# Waterloo Metro Quarter OSD Central Precinct (Building 2)

SSD-79307746

SSDA Response to Submissions

GFA - Level 03 Plan

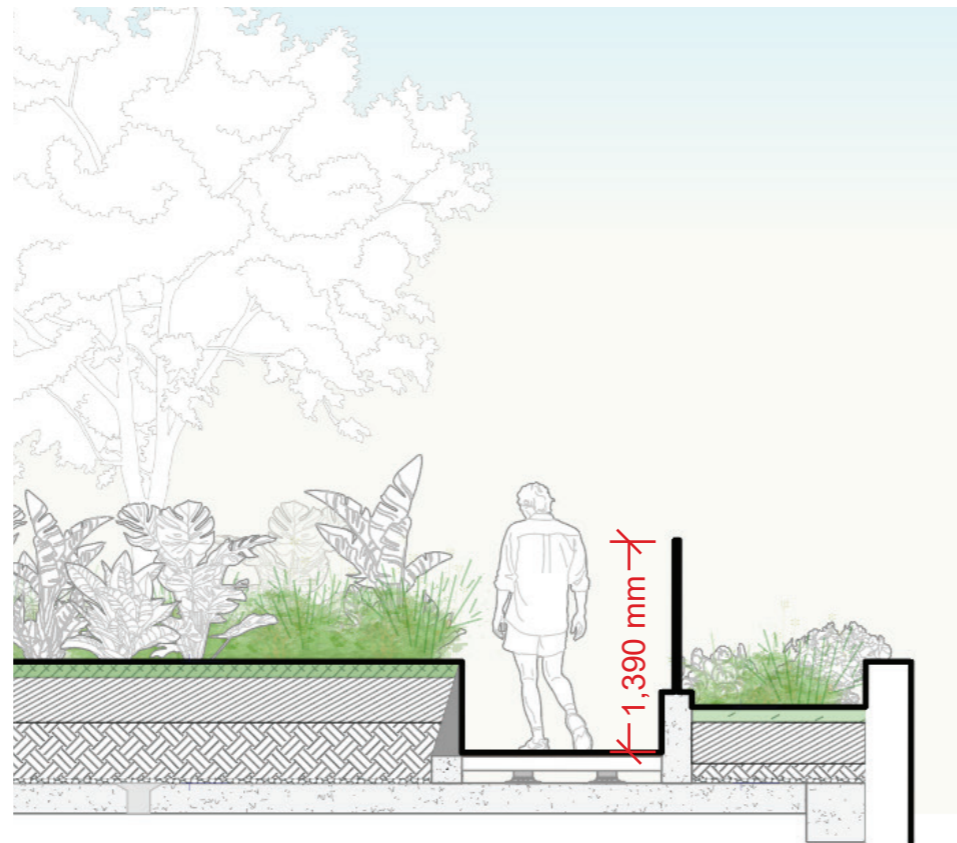
Provide further details, including supporting documentation and drawings to illustrate how the proposal achieves consistency with the maximum gross floor area (GFA) permitted under the Concept Approval .

This must include how the proposed exclusions (such as the Level 1 and 2 Childcare outdoor play areas, and the Level 3 communal areas ) in the Central Precinct meet the definition of GFA under the Sydney Local Environmental Plan 2012 (Sydney LEP).

The level 3 outdoor terrace is excluded from GFA as the terrace is open to the sky and the balustrade height is below 1.4m from finish floor.

**Level 03 South East Terrace Plan**

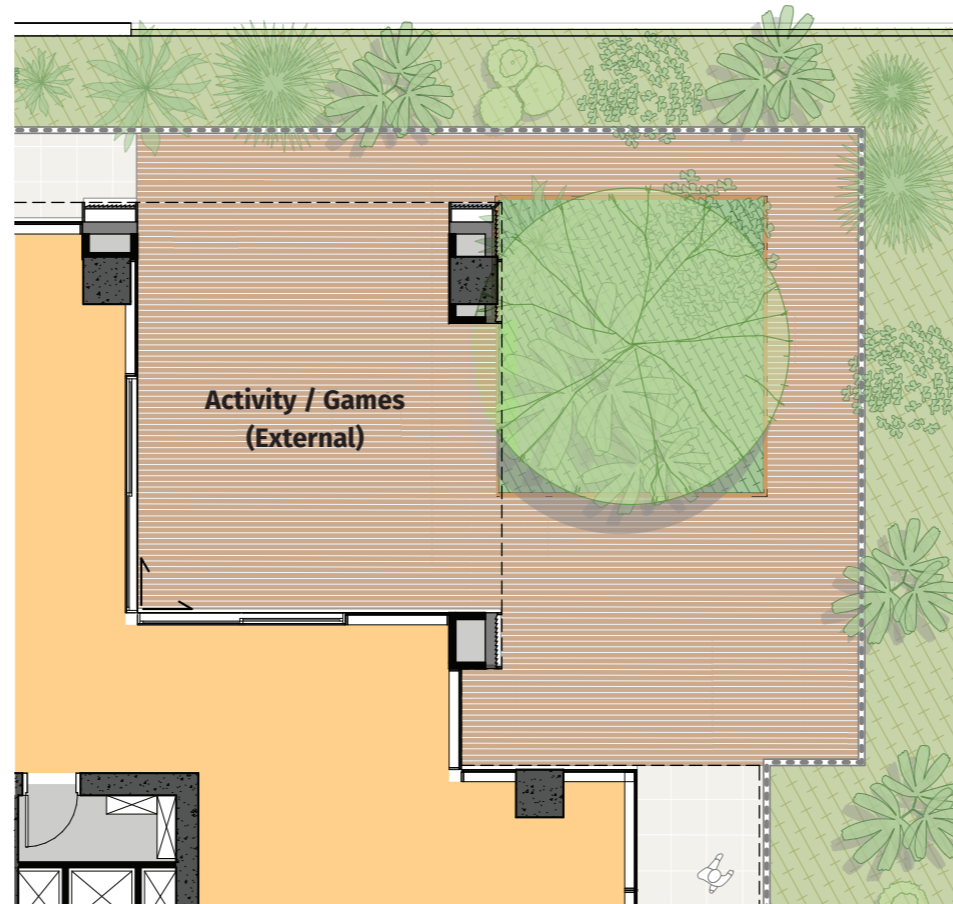
A sitting criteria for podium and rooftop spaces where outdoor seating / dining and kitchen / study areas are proposed (Sensor locations 124, 125, 128, 129, 130 and 131).

The proposed use at the south-east corner of the Level 03 terrace has been updated to an active games area. This change aligns with the standing and walking comfort levels recorded at sensors 124 and 125.
